Project Name McDuffie Terminal Improvements – New Assembly and Shop Buildings

Addendum 4
1 | Page

ADDENDUM NO. 4

11411- Task 3 - McDuffie Terminal Improvements – New Assembly and Shop Buildings
Contractor Questions

PROJECT NO: 4617 DWG NO: E-102 REV: 2

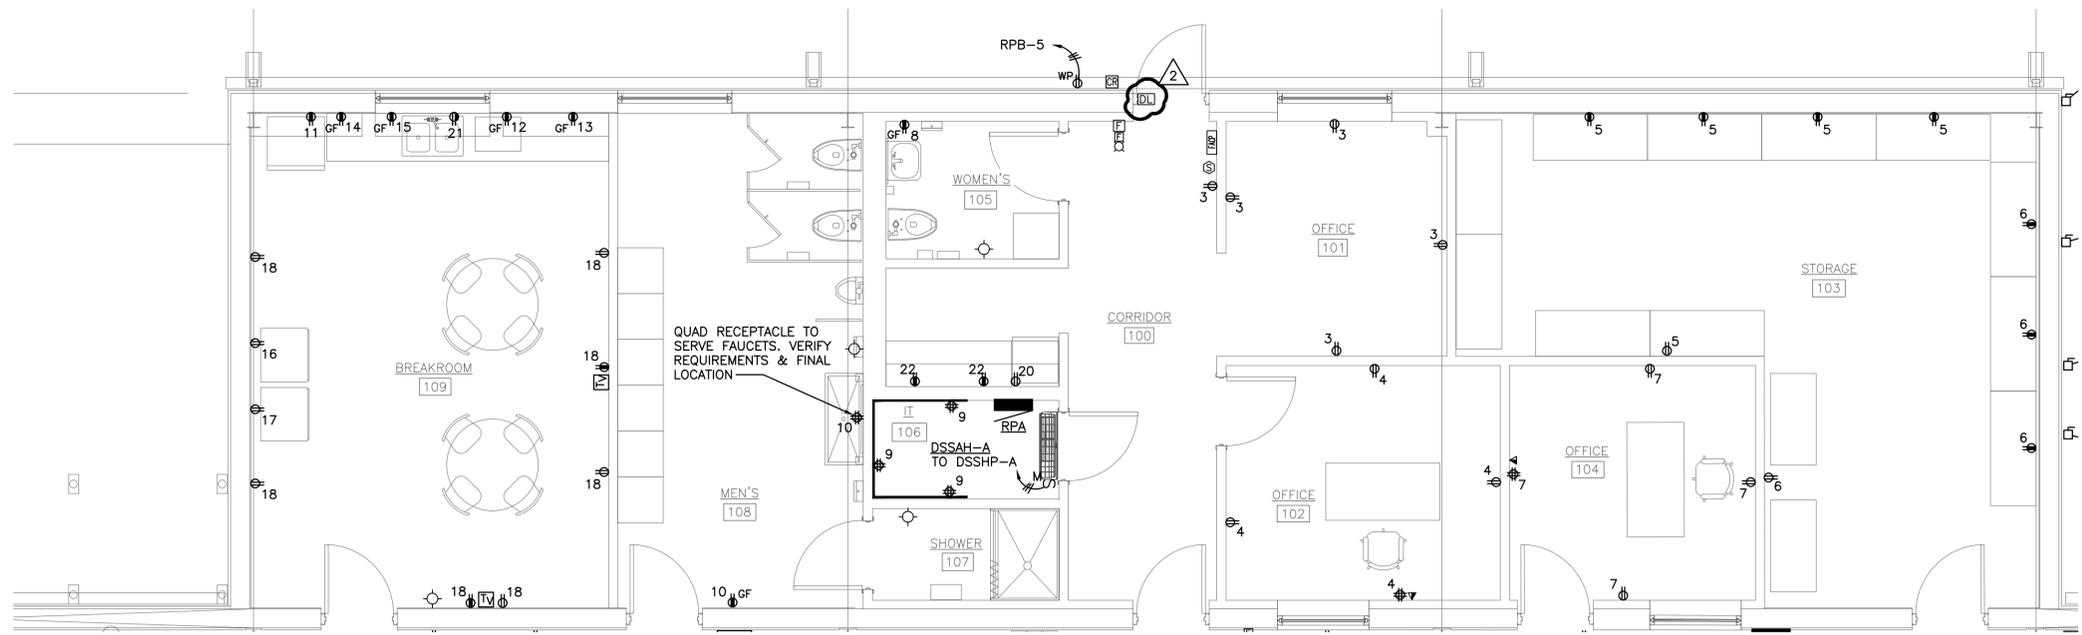
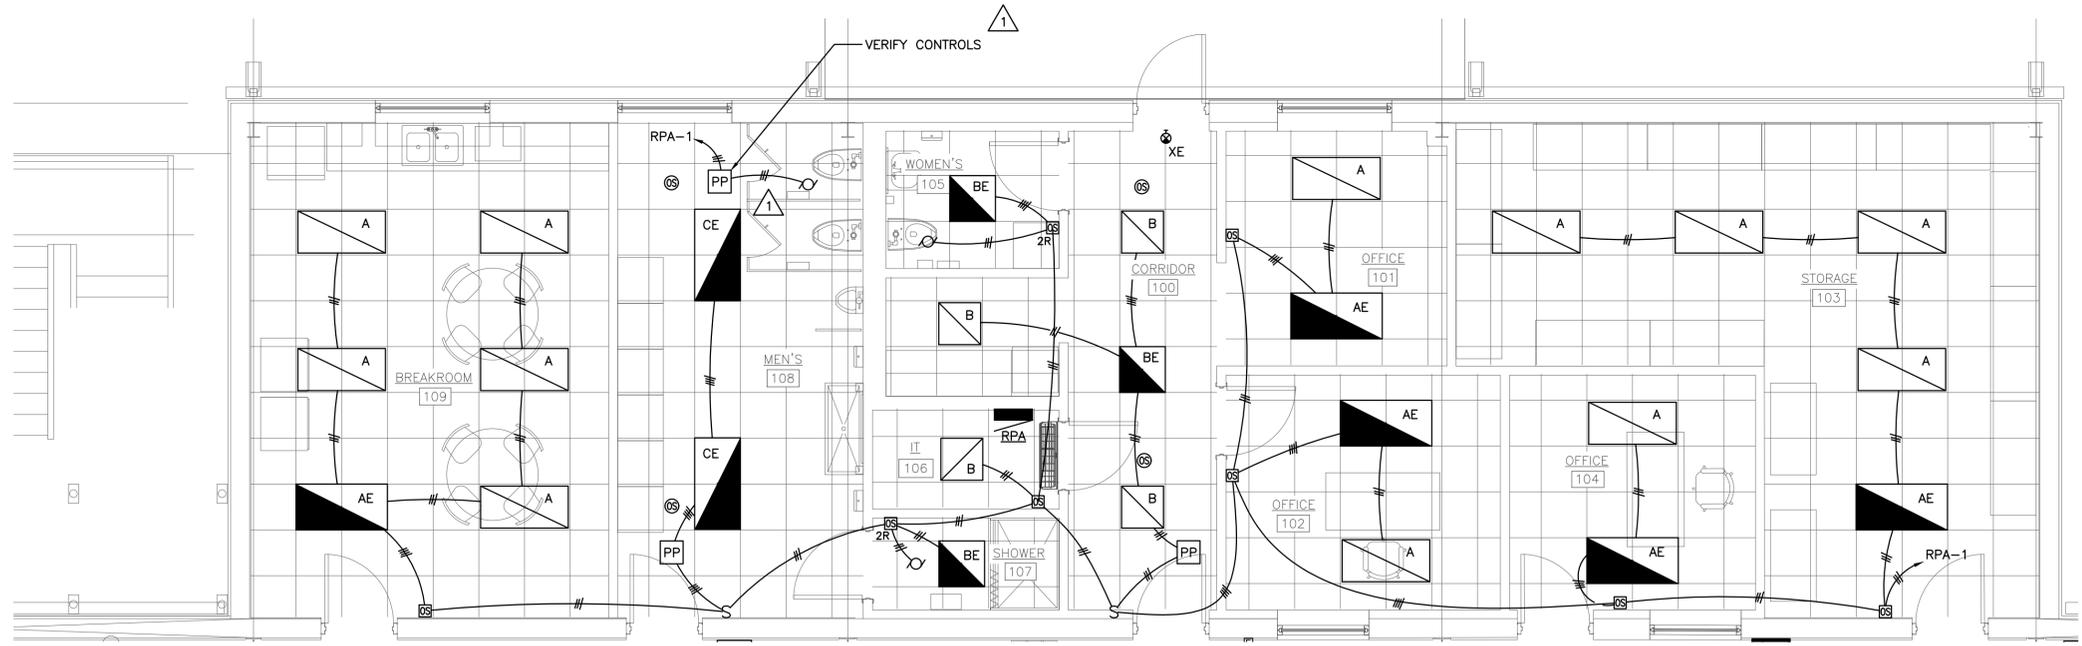
7. To clarify, the plans only call for boxes to install card readers, and not for an access control system to be installed, is that correct?
 - a. Plans call for pull boxes only. Supply and install of Access Control System is per the owner. See E102-2, E201-2, E304-2 (Fab Shop) and E303-2 (Assembly Bldg) for additional details.

2	ACCESS CONTROLS REVISION	GWS	GWS	GWS	03-25-26
E	ISSUED FOR BID	GWS	GWS	GWS	01-14-26
D	100% DESIGN REVIEW	GWS	GWS	GWS	09-09-25
C	95% DESIGN REVIEW	GWS	GWS	GWS	08-08-25
B	60% DESIGN REVIEW	GWS	GWS	GWS	06-11-25
A	30% DESIGN REVIEW	GWS	GWS	GWS	04-11-25
NO.	REVISION	DRAWN	CK'D	APPD	DATE
